## Product Change Notice (PCN)

PCN Number: **PCN-0454915-01**

Product(s) Affected: *PJ-096H*

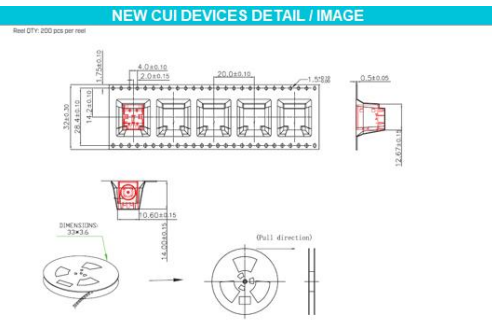
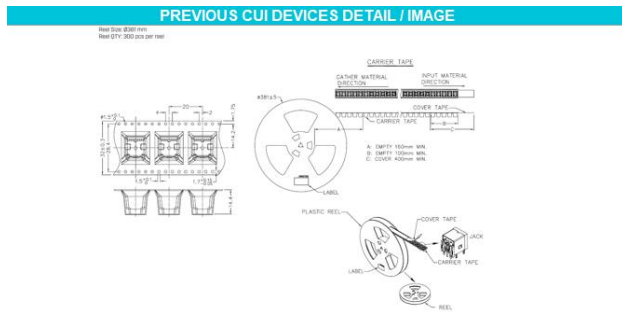
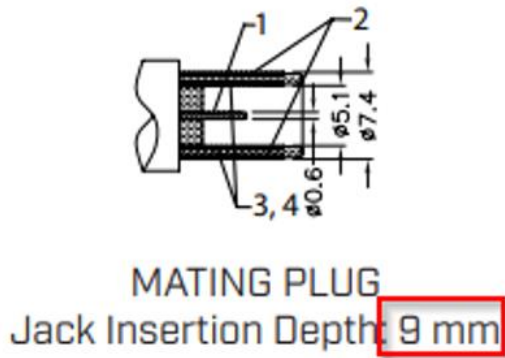
Description of Change: *Minor Housing and footprint differences. Material Change on the housing and terminals. See image Below*

PREVIOUS CUI DEVICES DETAIL / IMAGE			NEW CUI DEVICES DETAIL / IMAGE		
	MATERIAL	PLATING	DESCRIPTION	MATERIAL	PLATING/COLOR
terminal 1	copper alloy	gold flashed	terminal 1	copper alloy t=0.30	gold flash over nickel
terminal 2	copper alloy	gold flashed	terminal 2	copper alloy t=0.30	gold flash over nickel
terminal 3	copper alloy	gold flashed	terminal 3	copper alloy t=0.30	gold flash over nickel
terminal 4	copper alloy	gold flashed	terminal 4	copper alloy t=0.30	gold flash over nickel
spring	stainless steel		shield	brass t=0.35	nickel
shield	brass	nickel	insulator	LCP (UL94V-0)	black
insulator	PA10T
